## ADDENDUM 2 – JOB 28

TO: All prospective bidders on project NHU-4-002(116)149, Job No. 28 scheduled for the November 17, 2017 bid opening.

Addendum 2 is to address: Bid item, quantity changes, and signal standard types in medians.

US Hwy 2 & 42nd St SE  
Intersection Improvements

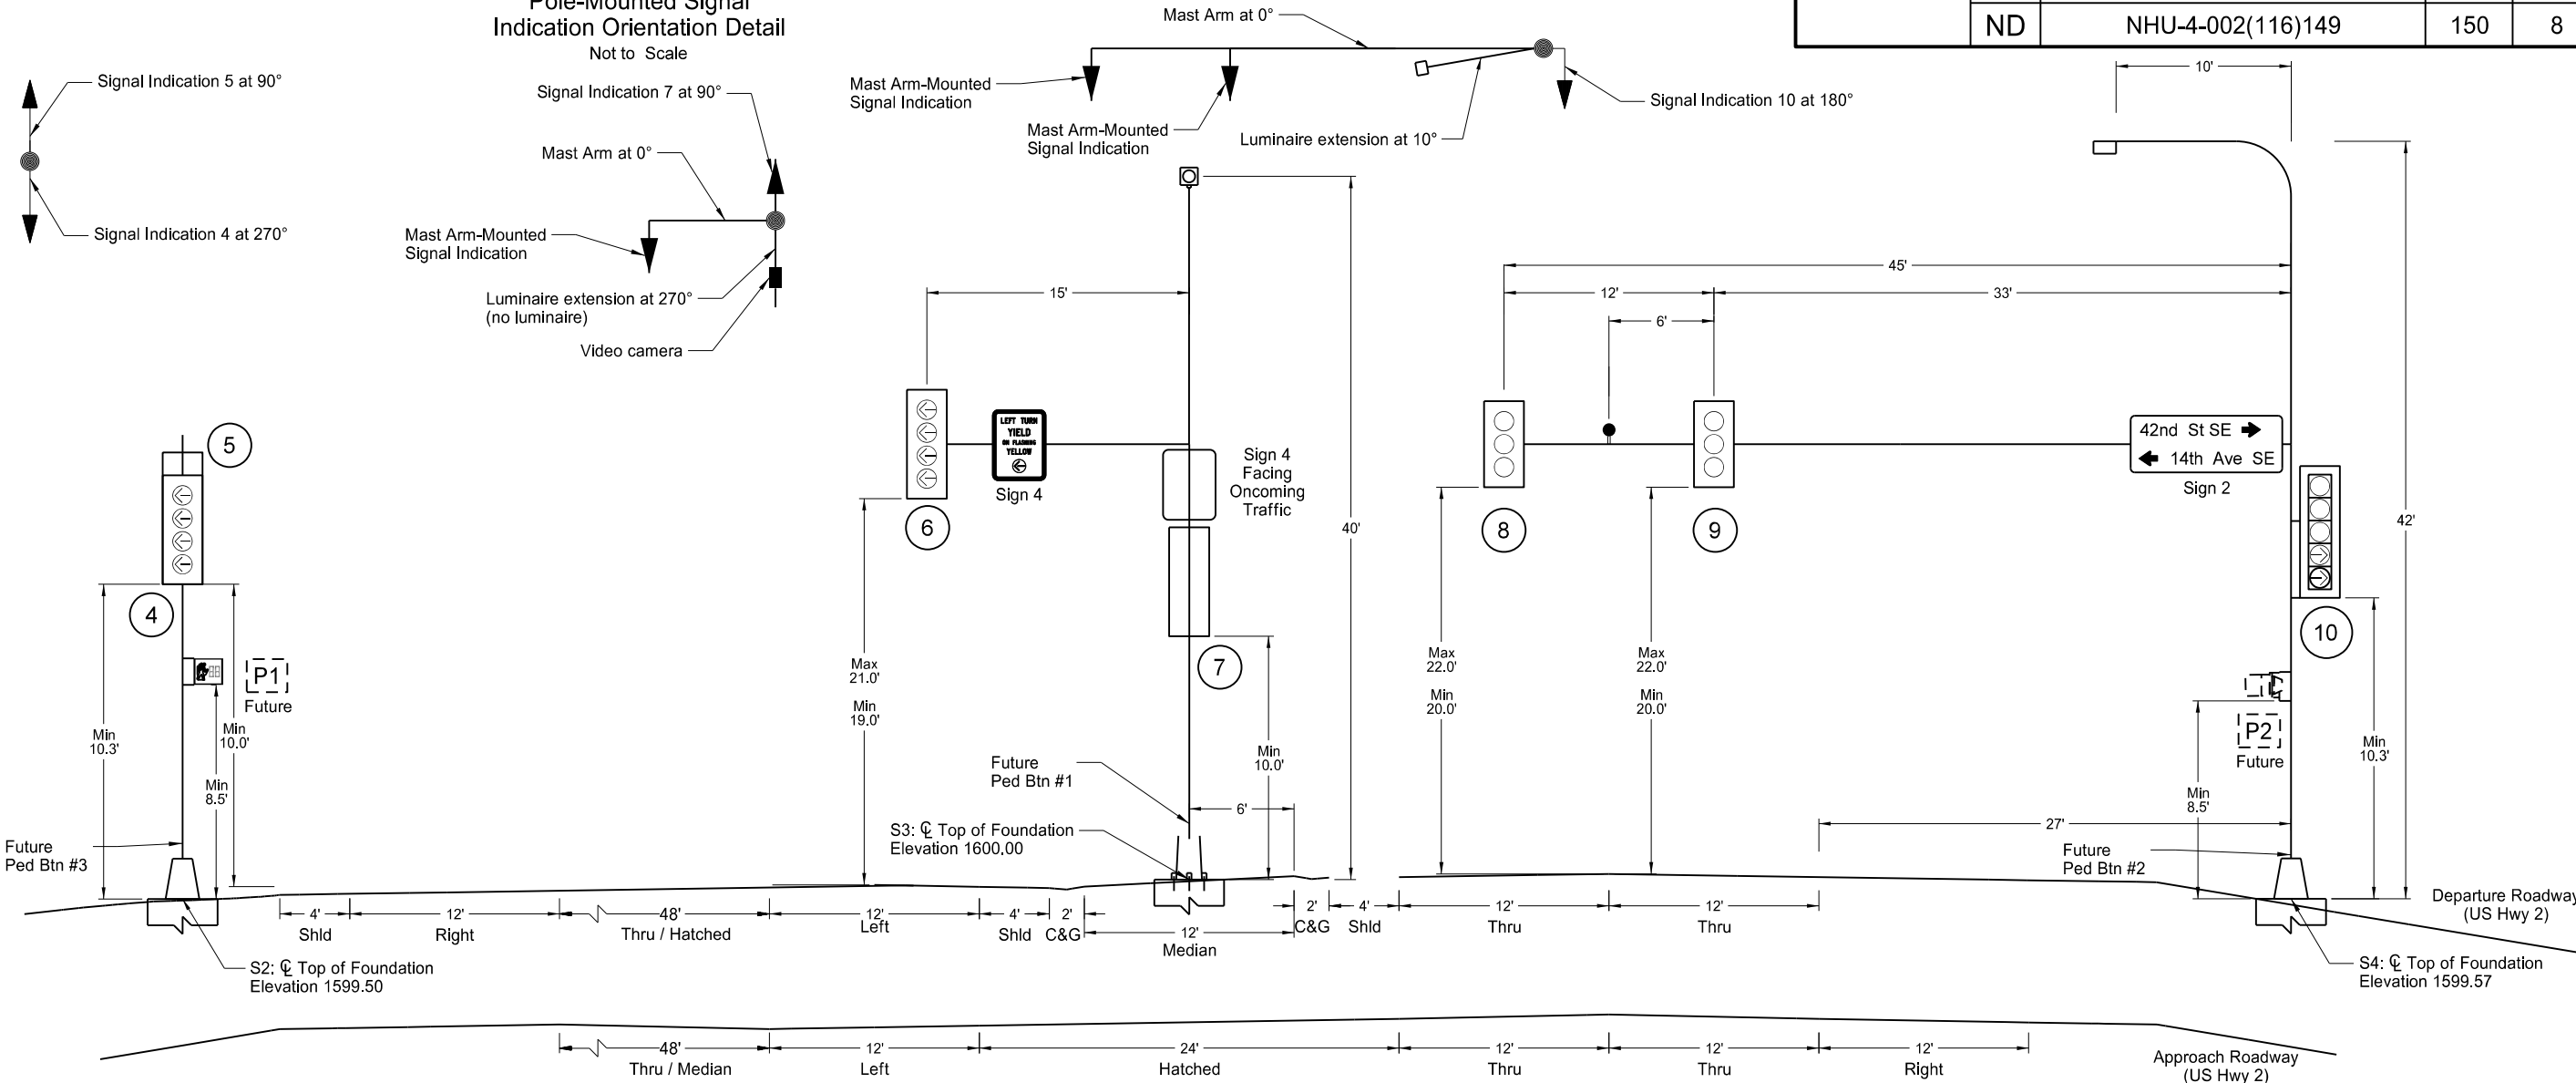
**Sheet 110-4:**

Added item 754 1104 Remove Sign Foundation 2 EA

Traffic Signal System  
US Hwy 2 & 42nd St SE  
Intersection Improvements  
Signal Standard & Head Locations

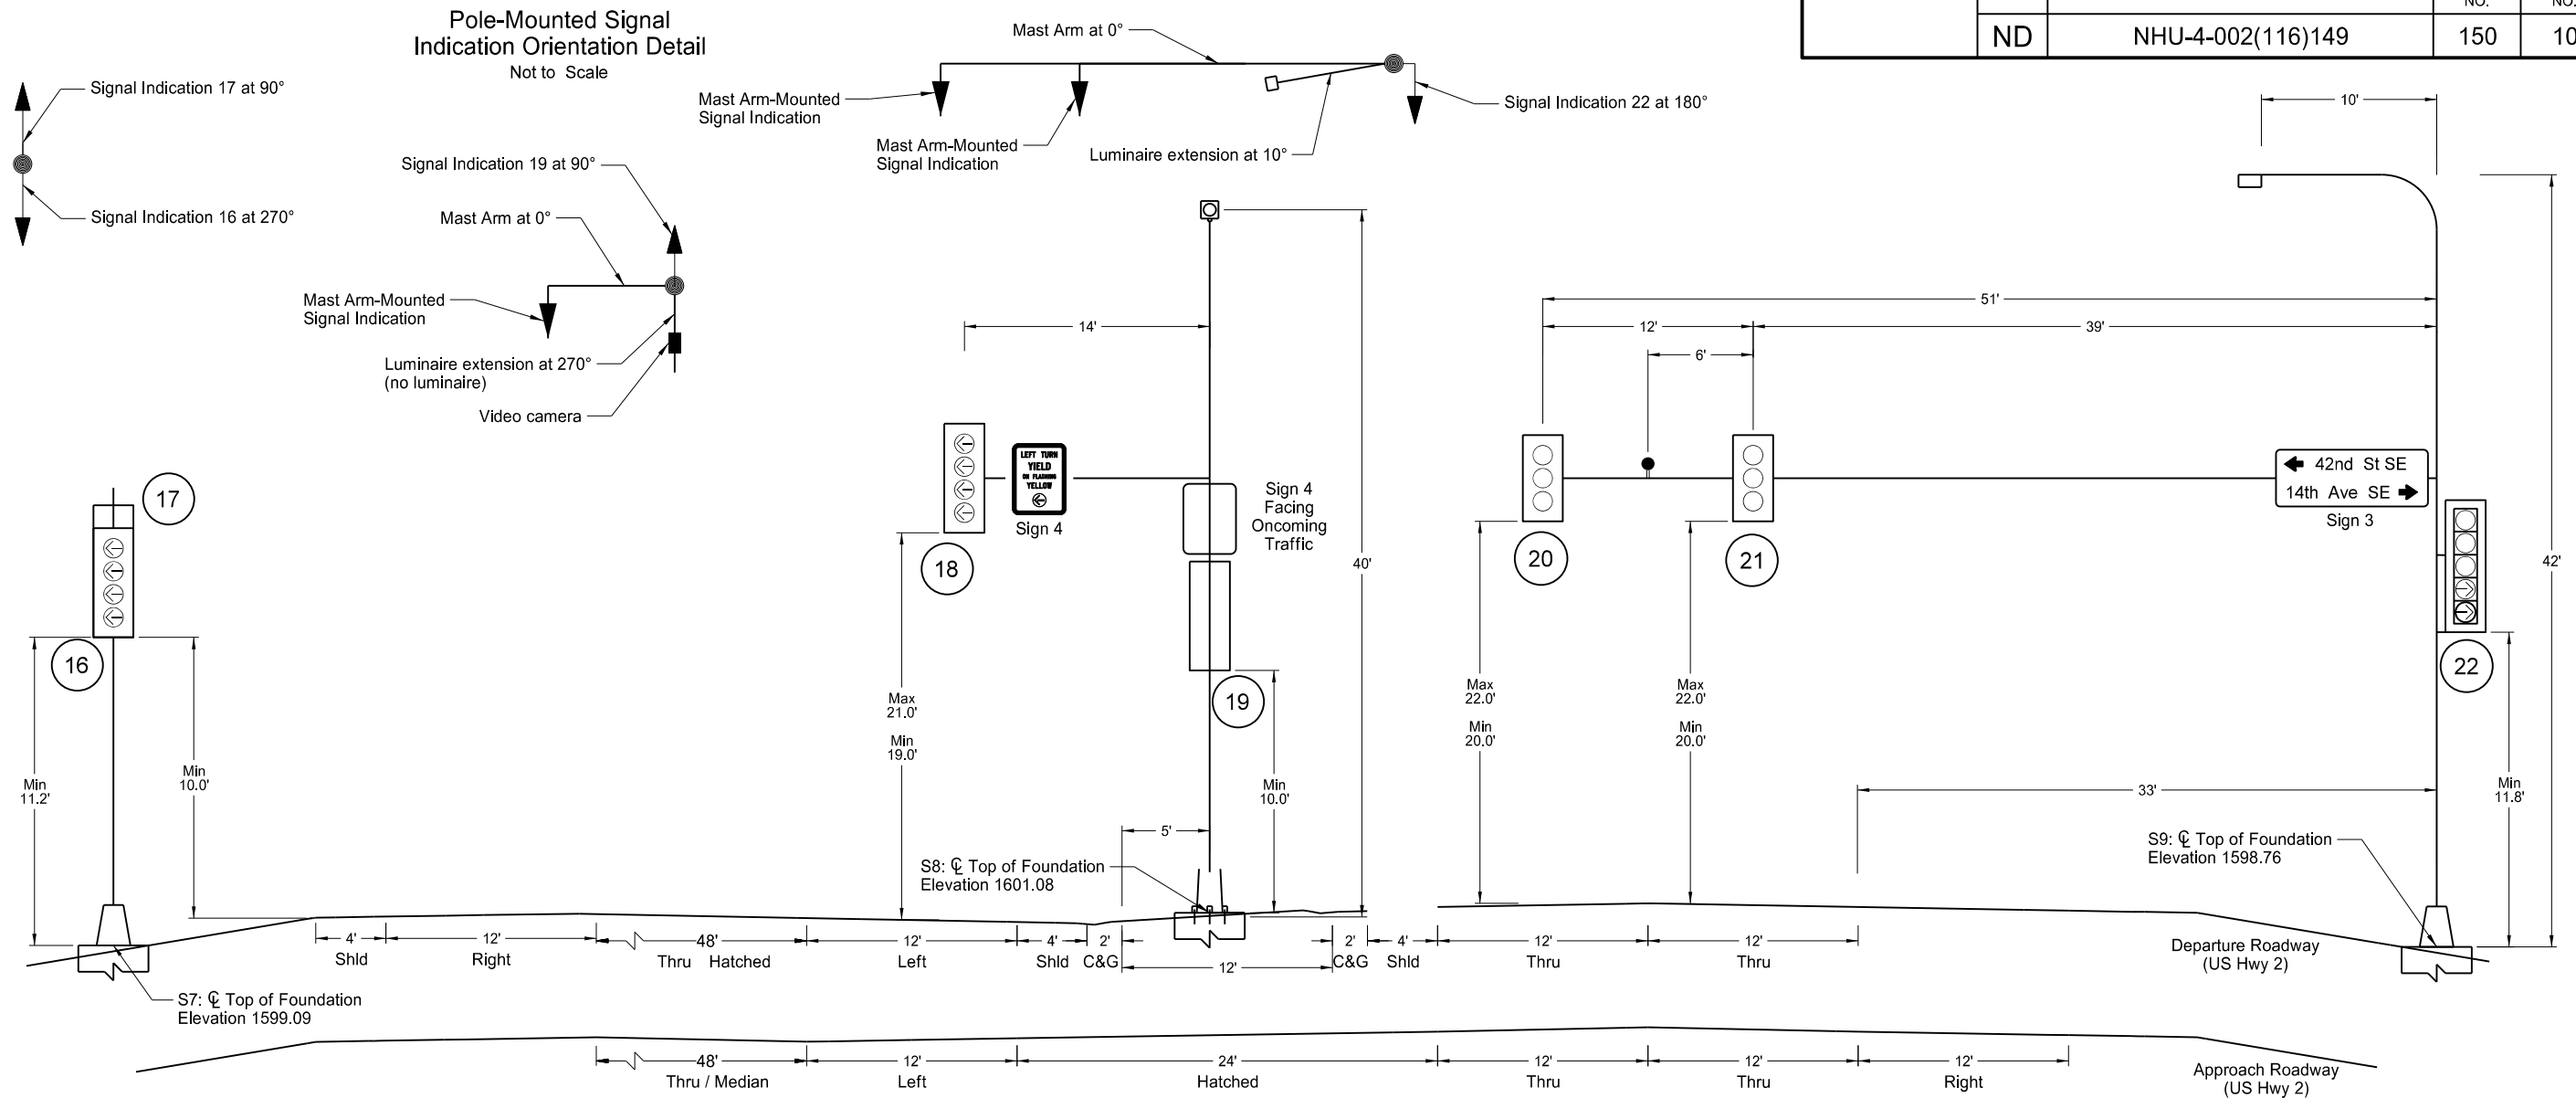
Sheet 150-8:

Revised legend to include Anchor Bolt Base and changed Signal S3 base to be Anchor Bolt Base.
